R867 Rev 0

February 2017

City of Greater Geraldton

**Whitehill Road Boat Launching Facility
Concept Investigations**

Figure 5.1 Option 1 Layout Plan

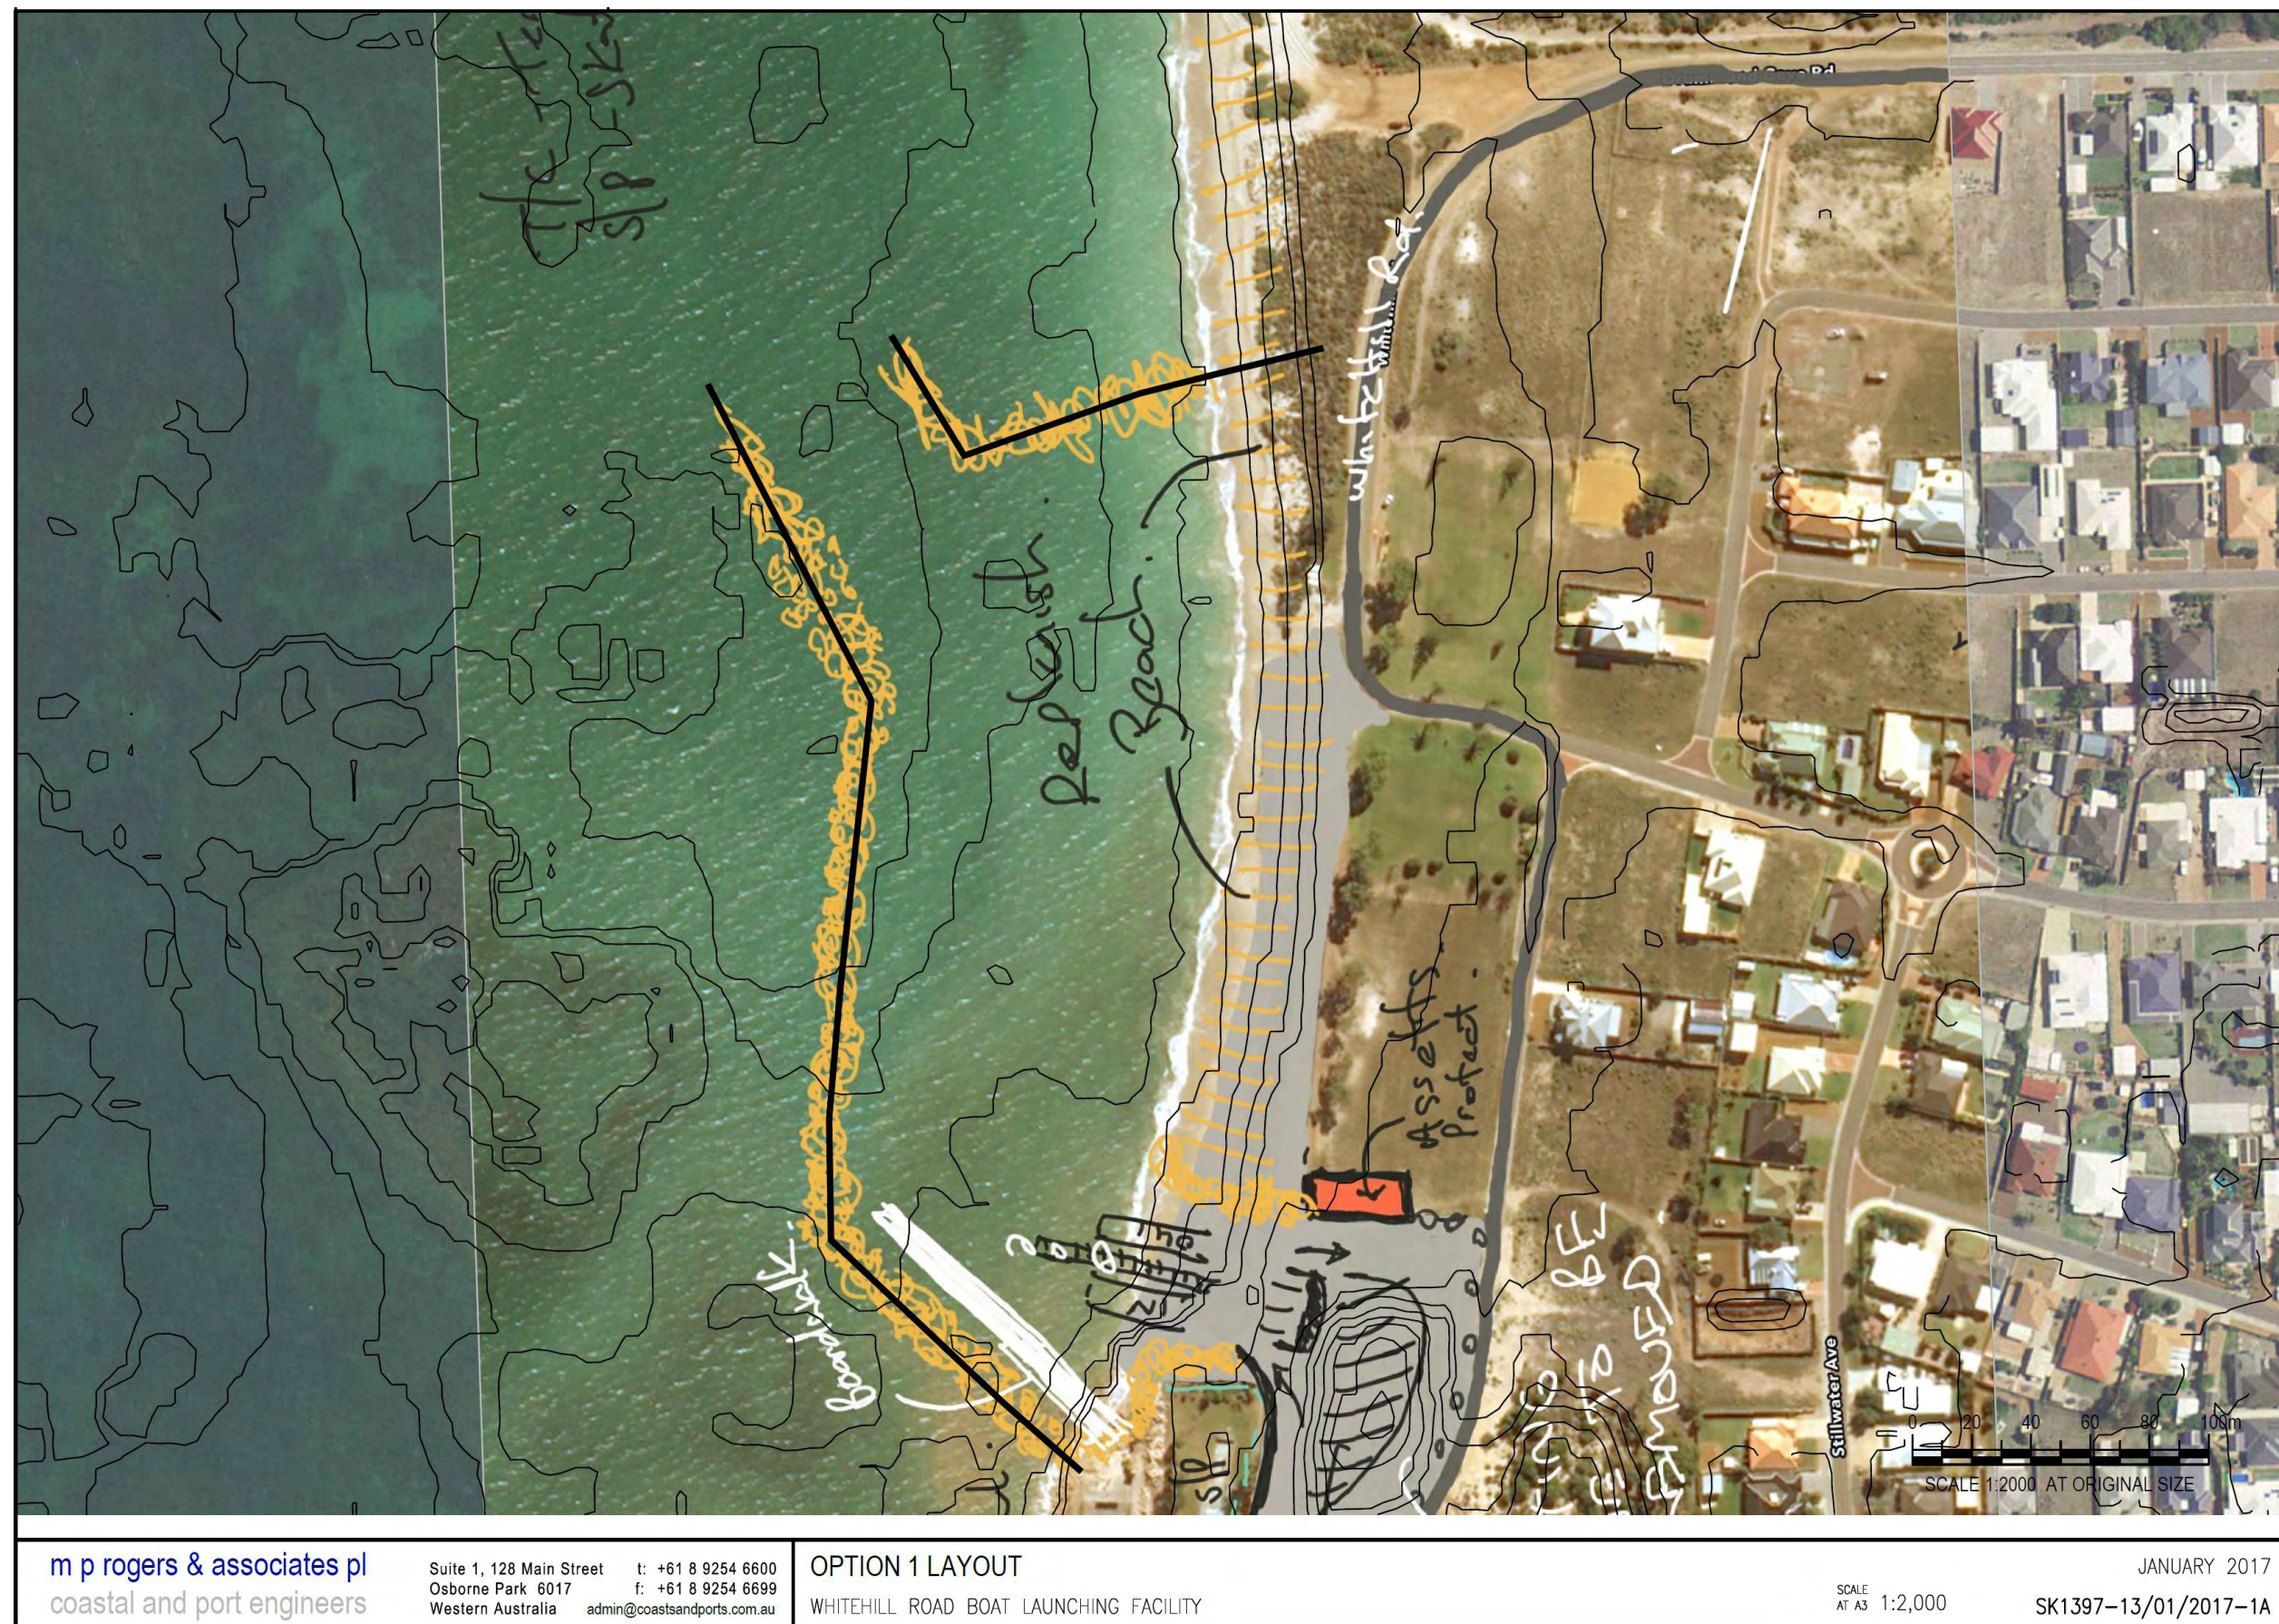
Option 1 provides a fully enclosed water area with the apparent intention of providing a sheltered beach within the enclosed water way (refer Figure 5.1). It should be noted that for this option the car and trailer parking area has not been costed for the area shown on the plan, but rather for the area presented in Figure 4.4. The reason for this departure from the plan is to preserve the vegetated dune that is present in this area and to instead locate the parking in the area immediately to the north, which is already cleared and levelled. An analysis of the potential issues and benefits associated with this option are presented in Table 5.1.

Positive Aspects	Negative Aspects
<ul style="list-style-type: none">■ Creates a large enclosed water area that would provide flexibility for future usage of the waterway.■ Provides protection to almost the full extent of Whitehill Road – it is unlikely that further erosion mitigation would be required.	<ul style="list-style-type: none">■ Creation of a large enclosed water area requires long breakwaters making the construction expensive.

Figure 5.2 Option 2 Layout Plan

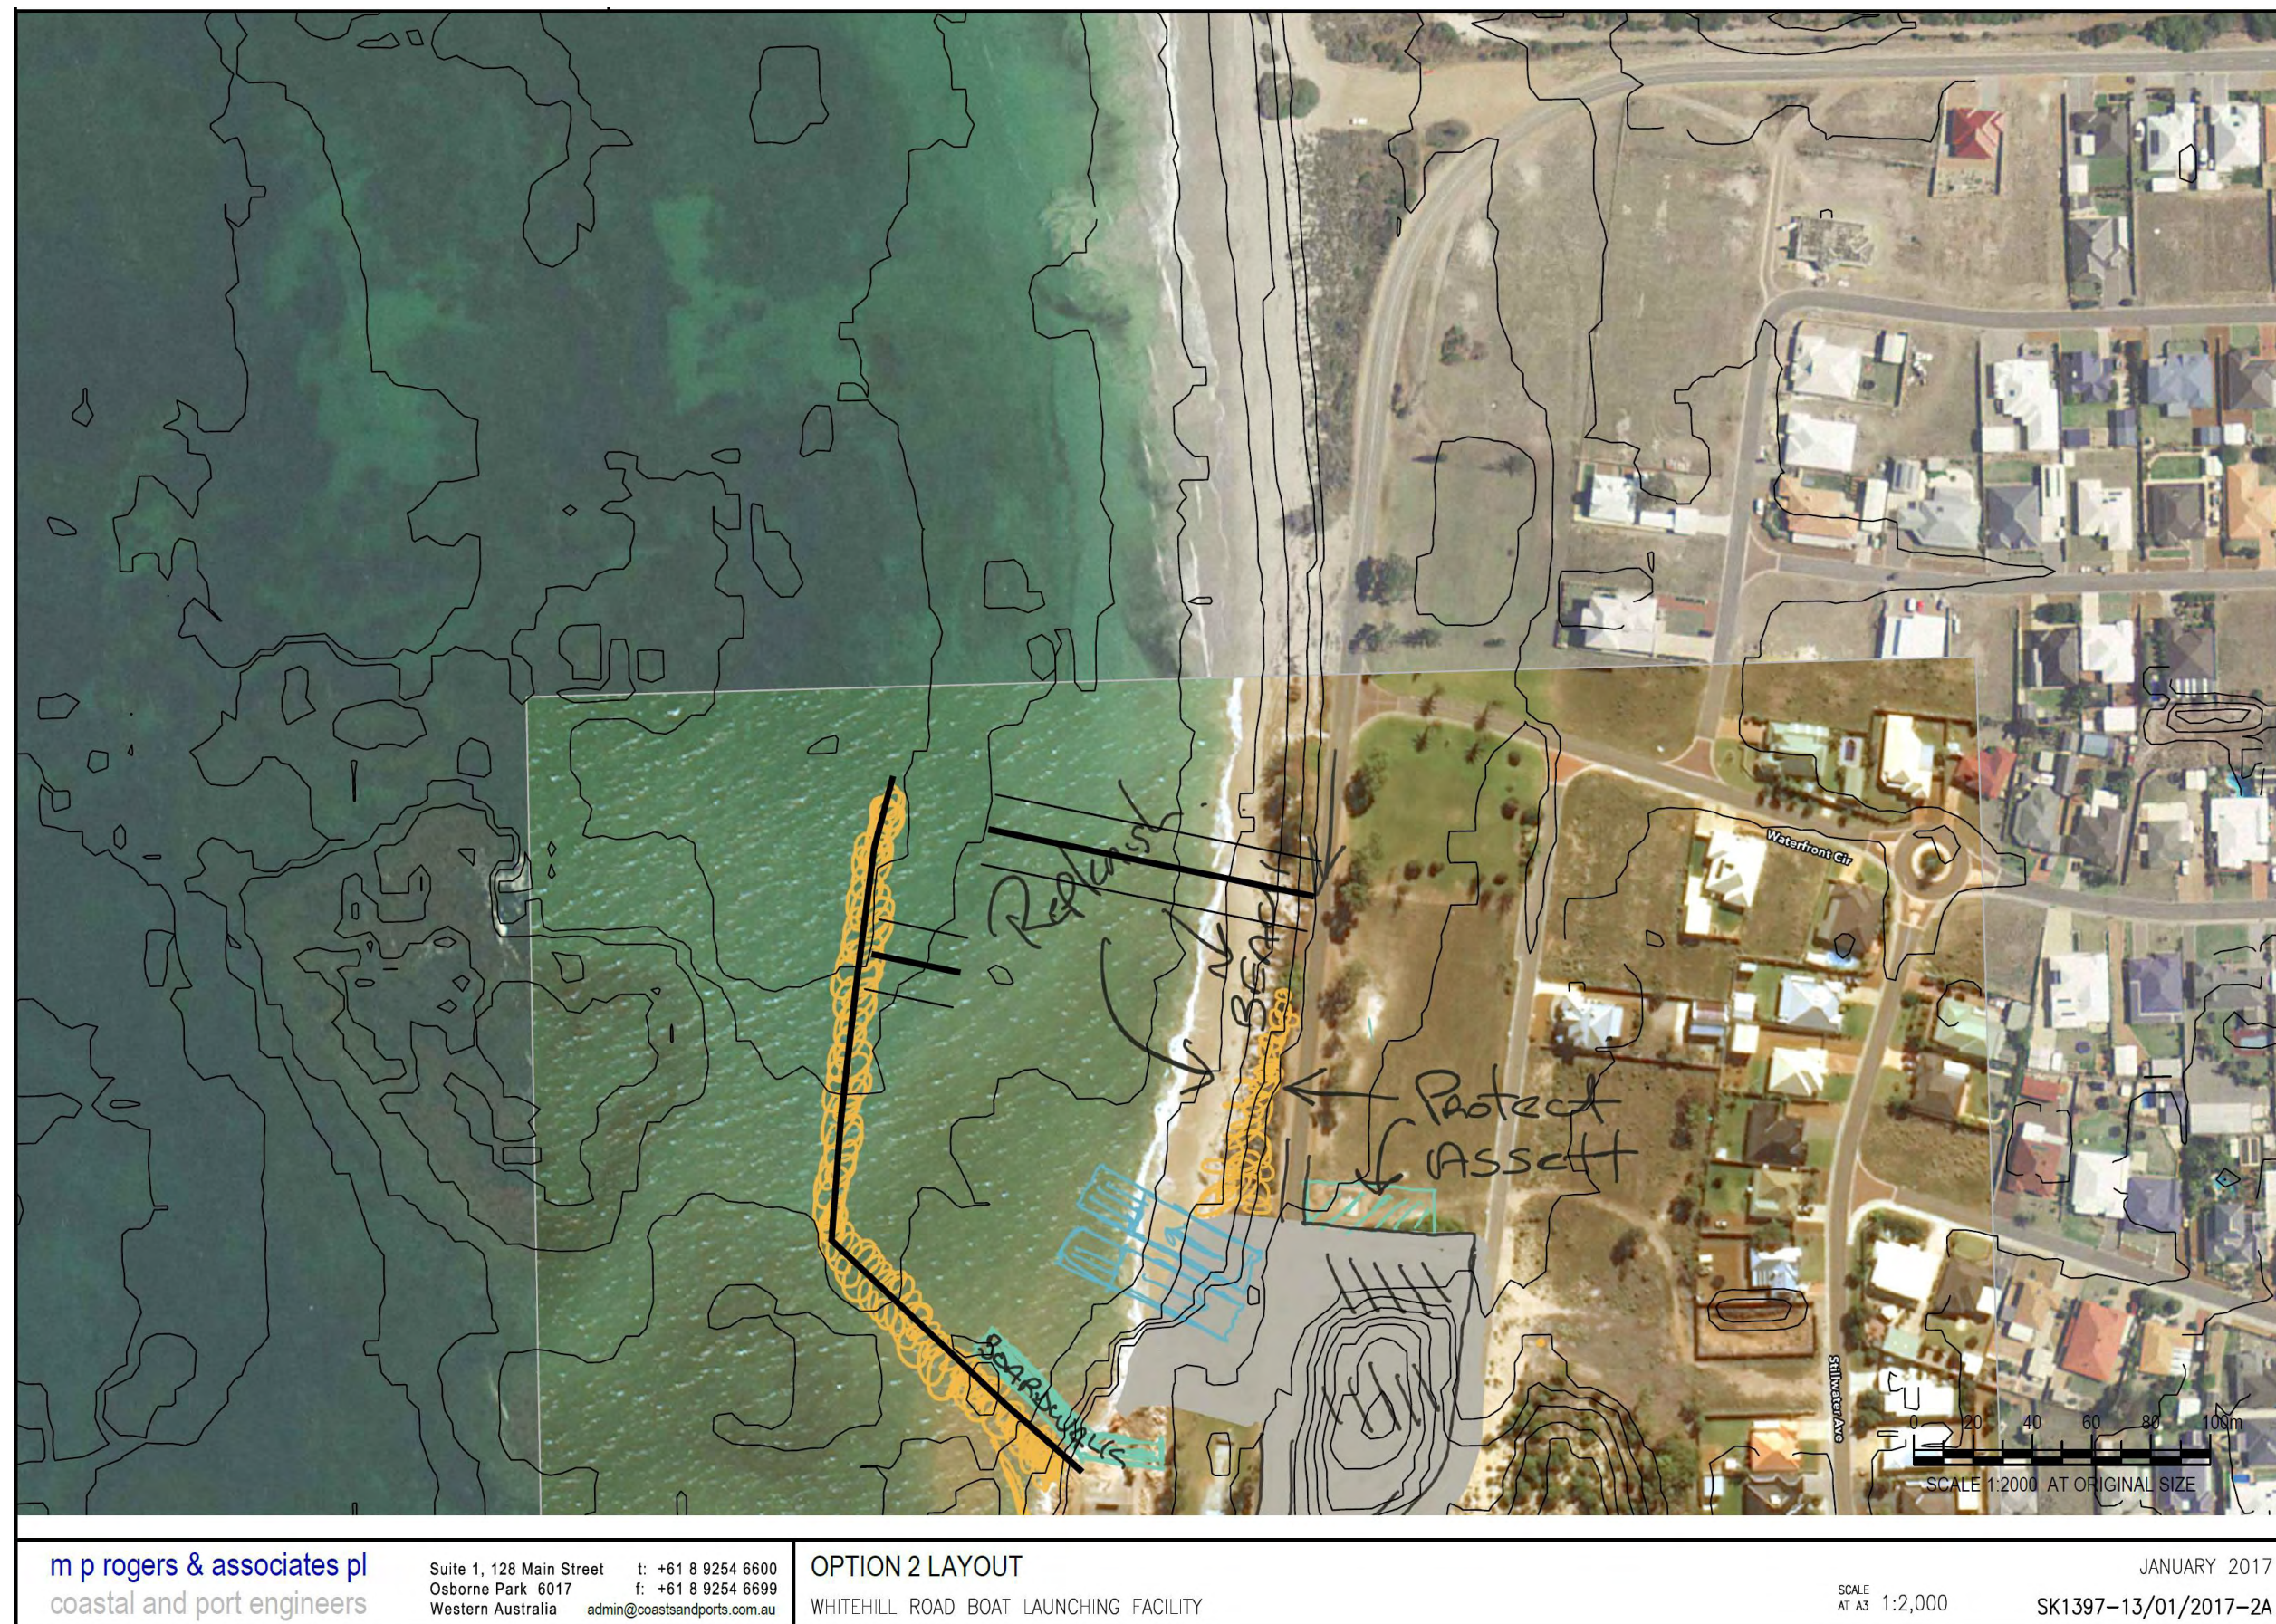
Option 2 provides a semi enclosed water area that would provide protection to the southern portion of Whitehill Road (refer Figure 5.2). It should be noted that, for reasons explained in Section 5.1, the car and trailer parking area has not been costed for the area shown on the plan, but rather for the area presented in Figure 4.4. An analysis of the potential issues and benefits associated with this option are presented in Table 5.3.

Positive Aspects	Negative Aspects
<ul style="list-style-type: none">■ Creates a semi-enclosed water area that would provide an improved wave climate for boat launching compared to current conditions.■ Provides protection to assets along the southern portion of the site.	<ul style="list-style-type: none">■ The semi-enclosed waterway would not provide the necessary level of protection from waves to ensure that the wave climate was suitable for launching and retrieving vessels at all times, as the facility would be vulnerable to waves arriving from the north and swell wave energy diffracting around the breakwater.■ The absence of a northern shore-perpendicular breakwater would leave the area sheltered behind the main breakwater vulnerable to an accumulation of sediment due to the diffracted wave pattern (similar to what has occurred at Whale World in Albany).■ Erosion adjacent to Whitehill Road would still be expected to the north of the facility.

The construction cost for this layout is comparatively low, however the absence of a shore perpendicular breakwater does mean that the facility would not be functional. To rectify this would require an additional expenditure of around \$0.5 million (excluding design and management fees, contingencies and GST) to construct a shore perpendicular breakwater. This would increase the total all-inclusive cost for the first stage to be between \$3.20 and \$3.70 million.
